Appl. No. 09/807,225
Amdt. Dated July 15, 2004
Reply to Office action of May 18, 2004

Amendments to the Drawings:

Replacement Sheet
 Serial No.: 09/807,225
 Filed: April 9, 2001
 Conf. No.: 2717
 Atty. Docket No.: 33475
 Sheet 1 of 1

PRIOR ART FIG. 13

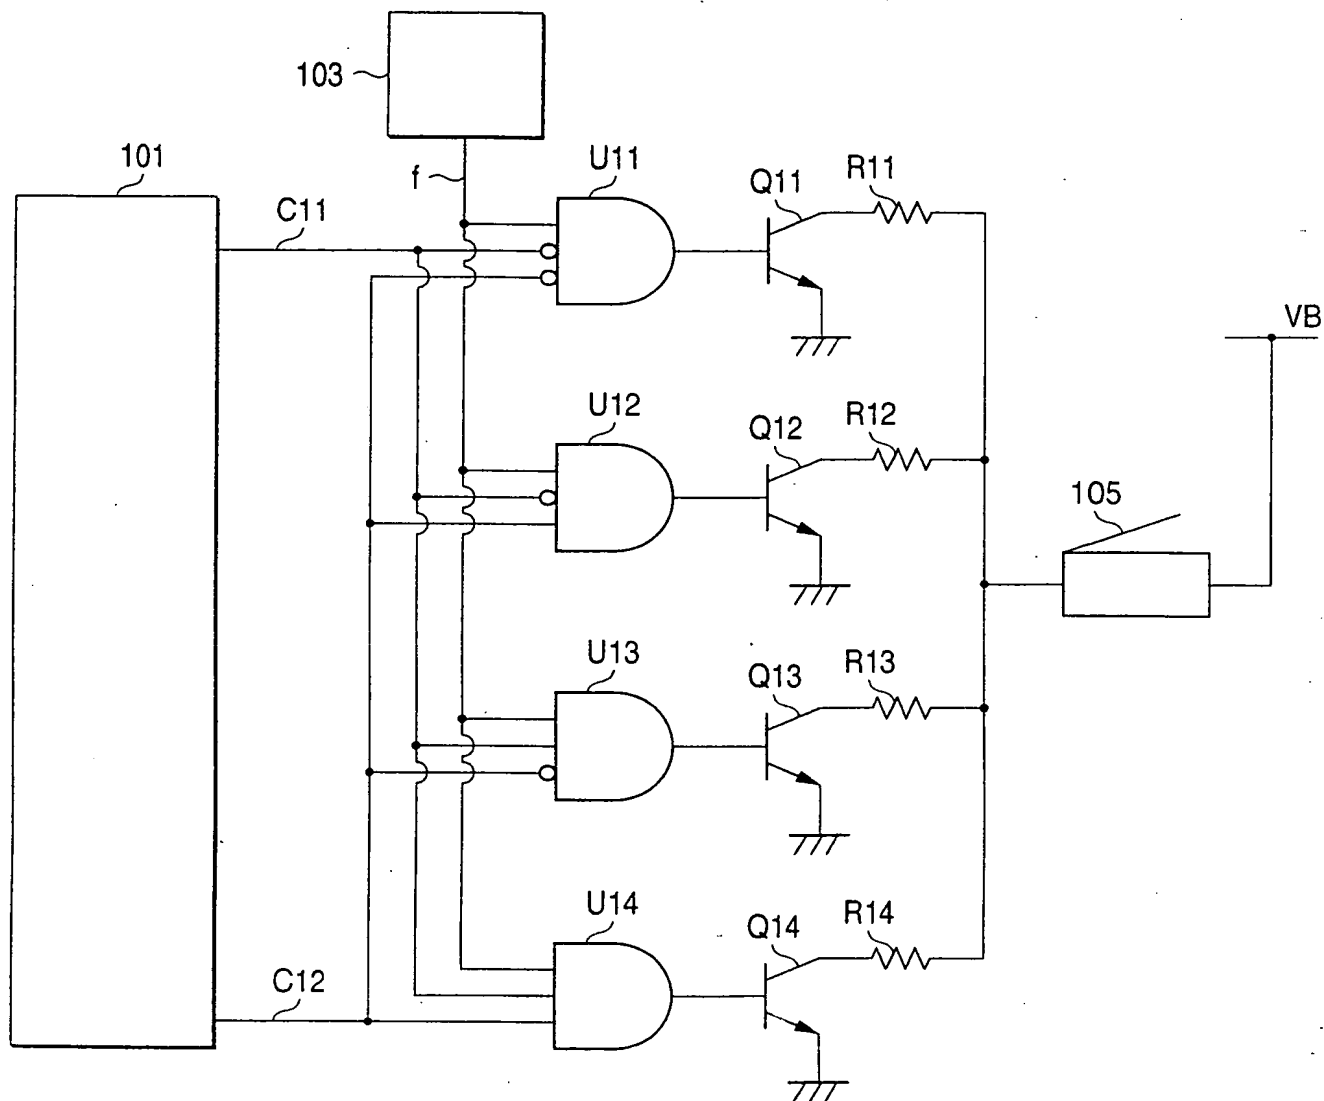
The attached sheet of drawings includes changes to Fig. 13. This sheet, which includes Figs. 13 and 14, replaces the original sheet including Figs. 13 and 14. Fig. 13 has been designated as being "Prior Art".
